Product Change Notification (PCN)

PCN Number	510049	Date Issued	May 14, 2021
Reason for Change	Change to Product		
Change Type Description	This letter is to inform you that changes are being made to the part(s) identified in this Notice. The change may affect the fit, form, function or appearance of the parts, or it may result in a change to the specification. The pictures below show an example of the possible differences.		
Reason for Short Notice	Corrective Actions		
Assessment of Change	Test report/Specification Test Report		
Internal Molex Qualification Date	May 28, 2021		
Sample Availability Date (Changed Part)	May 28, 2021		
Planned Implementation Date	July 01, 2021		
Method of Identifying Change	Lot information on label

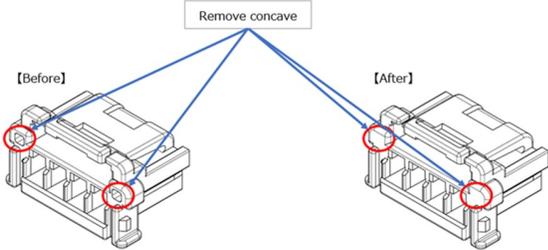
- Change Point:
 - Remove the concave and then return to the original size of the air venting
- Reason:
 - To reduce quality risks of Bubble & Gate flash
- Product Impact
 - Impact to cosmetic appearance. But there is no change of Fit or Function.
- Part Number Impact
 - 505151-0301/505151-0401/505151-0501/505151-0601/505151-0701/505151-0801/505151-0901
 - 505151-1001/505151-1101/505151-1201/505151-1301/505151-1401/505151-1501/505151-0300
 - 505151-0400/505151-0500/505151-0600/505151-0700/505151-0800/505151-0900/505151-1000
 - 505151-1100/505151-1200/505151-1300/505151-1400/505151-1500
- Qualification Reports and samples available upon request after 1st of May,2021
